Date: 10 May 2018
To: Thai Aviation Services Limited
Attention: Grant Robinson
Regarding: Engine Mount Strut Sliding Bushing Dash Number-Clarification
Technical Case #: C0094448

76300-77101 Sht 3

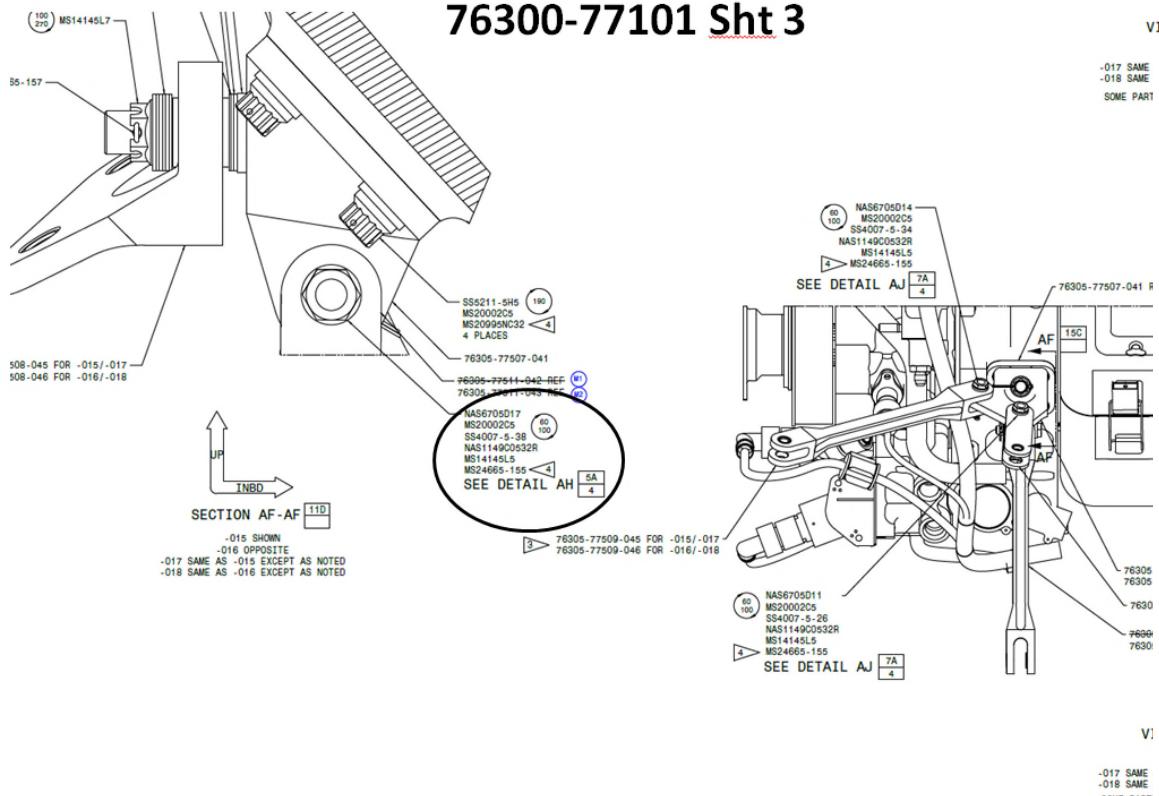
The gap between the MS20002C5 washer and the strut face is a fixed relationship, whereby there should be no change in this gap through time. If the SS4007-5-34 bushing is installed, and the MS20002C5 washer does not contact the strut face, there is no problem. Even if the spherical bearing exhibits wear, the washer-to-strut gap will not change. If the washer is scoring the strut face, then one of the stack-up components is out of tolerance, and needs to be replaced.

SS4007-5-34 applicability is limited to 761022 and subsequent. SS4007-5-38 can be used on all S-76Ds. If the customer would like to see a larger gap between the washer and strut face, they can replace the SS4007-5-034 bushing with the SS4007-5-038. It will have no effect on the strut / bearing functionality. Please see attached.
